BULLETIN #168

## MILLER GOLD SEAL 160i

### OUTPUT CURRENT DECREASES

Fig 1

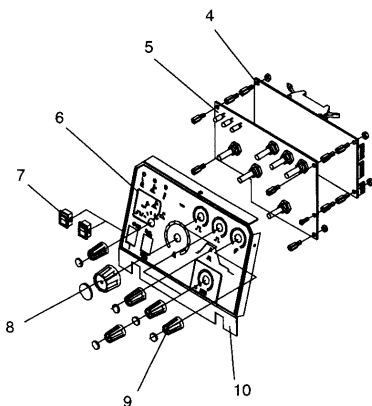
There have been some instances where the current output of a Gold Seal 160i has decreased while welding, or while turned on and idle.

This can be caused by the Local/Remote Selector Switch on the control panel (located in the lower left corner) being set to "Remote Control" when there is no remote control connected. This switch should be set to the "0" position (pushed in at the top) when a remote control for output current is not connected. It may be necessary to turn the machine off/on after changing the position of this switch. There have been a small number of cases where a poor connection to this Local/Remote Switch has caused a similar problem. The problem has been identified as a poor connection in the loom which links the Local/Remote Switch to the Logic PCB. Miller Europe have provided replacement looms which can be fitted to prevent this problem.

1. Remove the cover.
2. Remove the 4 nuts to detach the Logic PCB (item 4, Fig 1). Note the washers on both sides of this PCB at one corner only.
3. Remove the old loom and fit the new one, maintaining the same connections.
4. Refit all components and test.
